## Memorandum

**Subject:** **Modification #1 to Phase 2 Field Sampling Plan**  
700 South 1600 East Tetrachloroethene Plume Superfund Site,  
Salt Lake City, Utah

Minor Field Modification #1  
 Phase 2 Remedial Investigation Work Plan  
 OU1 700 South 1600 East PCE Plume  
 Salt Lake City, Utah

**Figure 1**  
 Leapfrog Cross Section  
 through MW-08, MW-13 and MW-14

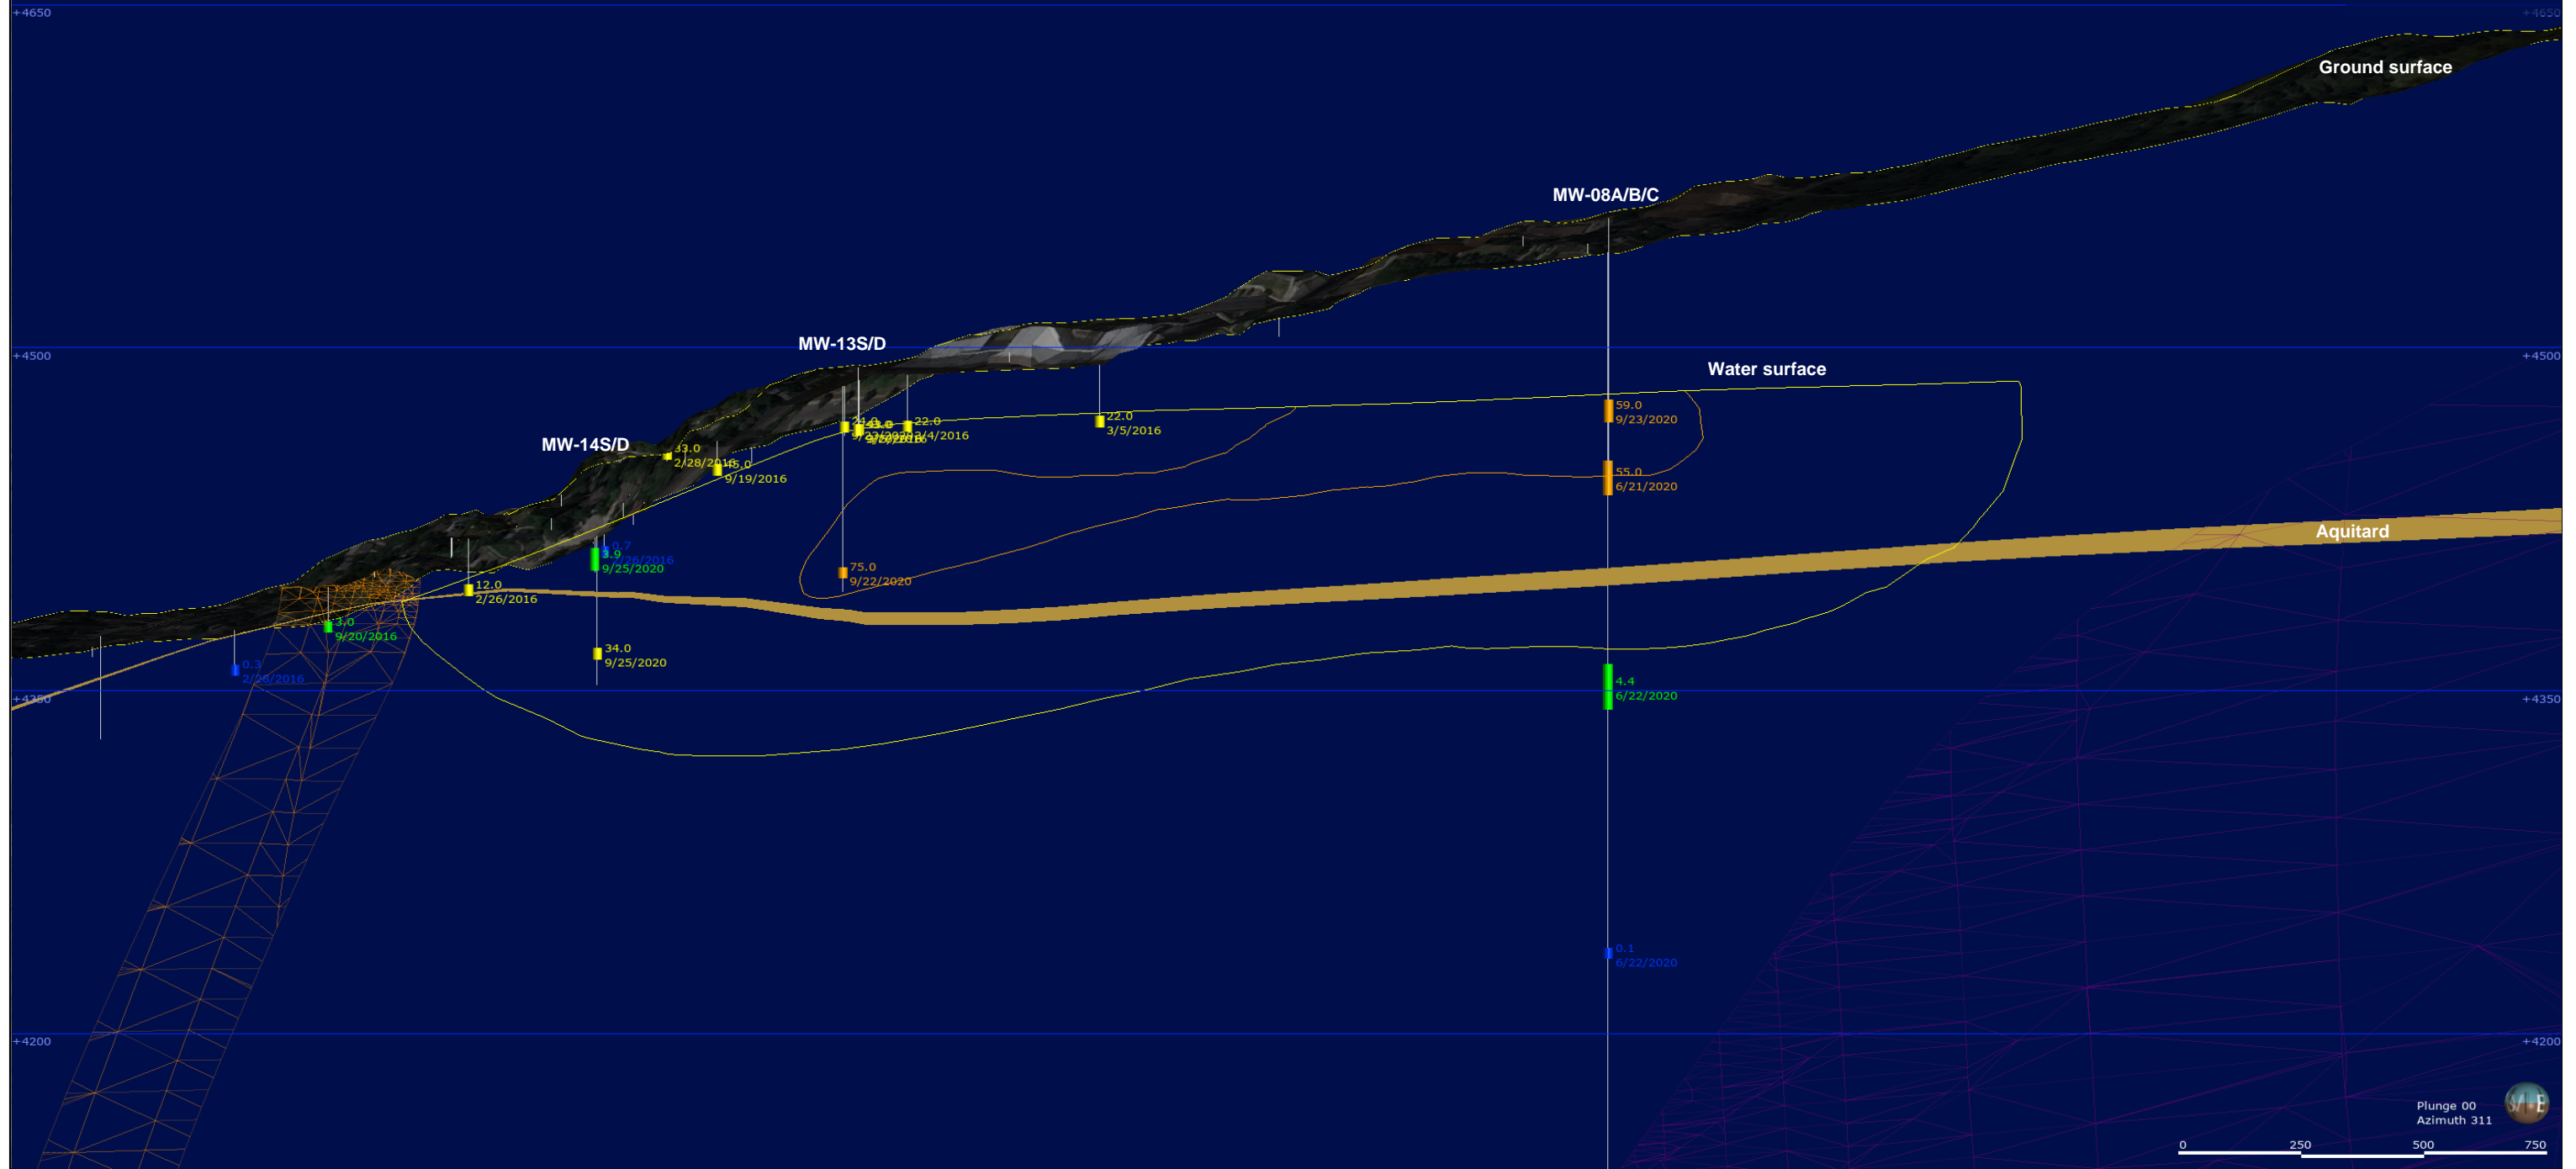
This MFM includes the rationale and description of work for the installation of an additional groundwater monitoring well, MW-13L. Currently, the MW-13 monitoring well pair consists of MW-13S (screened interval 15.5–20.5 feet below ground surface [ft bgs]) and MW-13D (screened interval 79–84 ft bgs). As can be seen in the cross section presented on **Figure 1**, both MW-13S and MW-13D are screened above an aquitard, within the shallow aquifer. Monitoring well MW-13L will be drilled and constructed below the aquitard within the deeper aquifer, to provide vertical delineation of the plume.

**Figure 2**  
Q3 2020 Groundwater PCE and TCE Results and  
Approximate Extent of PCE in Groundwater  
Shallow Aquifer

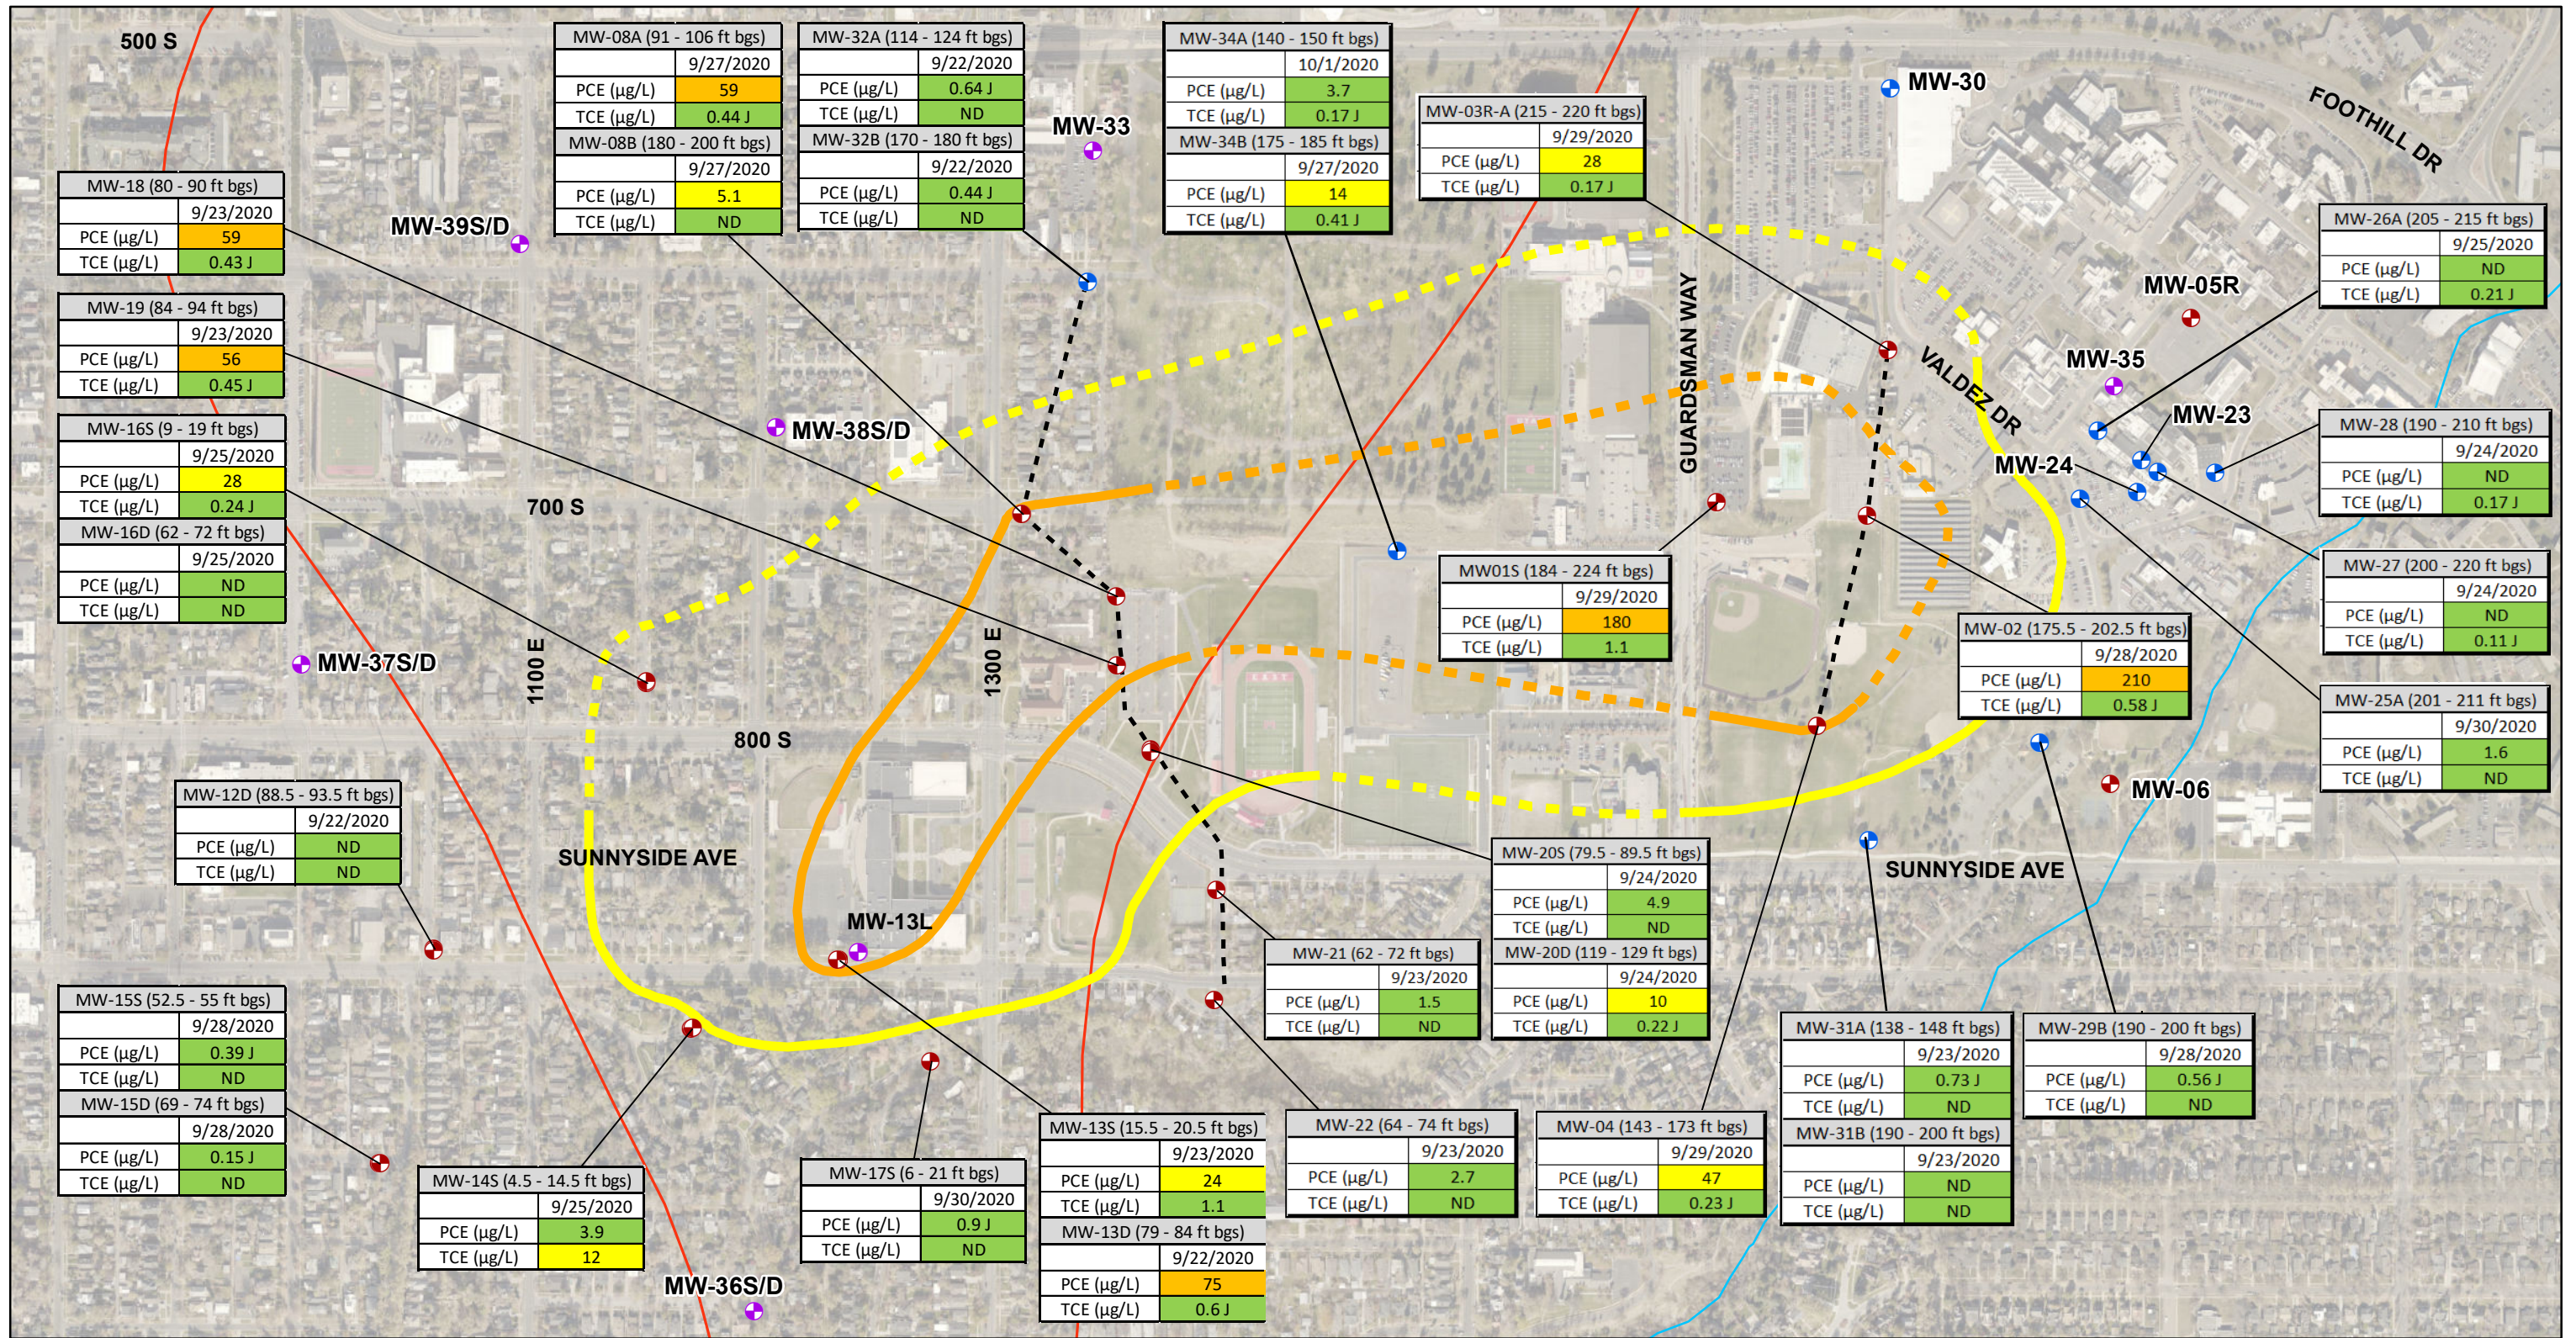
**Figure 2** shows the current extent of the PCE groundwater plume in the shallow aquifer based on the data collected during the 3Q (Sep 2020) sampling event. In the shallow aquifer, the PCE concentration was 24 micrograms per liter ( $\mu\text{g/L}$ ) in MW-13S, 75  $\mu\text{g/L}$  in MW-13D, 3.9  $\mu\text{g/L}$  in MW-14S, 59  $\mu\text{g/L}$  in MW-08A, and 55  $\mu\text{g/L}$  in MW-08B (**Figures 1 and 2**). In the deep aquifer, the PCE concentration was 4.4  $\mu\text{g/L}$  in MW-08C and 34  $\mu\text{g/L}$  in MW-14D (**Figures 1 and 2**). As can be seen on **Figure 2**, there are limited monitoring wells in the downgradient area of the plume that are

screened in the deep aquifer. Because of the lack of downgradient wells and the lack of vertical delineation at MW-13S/D, a well screened within the deep aquifer at MW-13S/D (referred to as MW-13L and shown on **Figure 2**) is planned to further define the extent of the PCE groundwater plume.
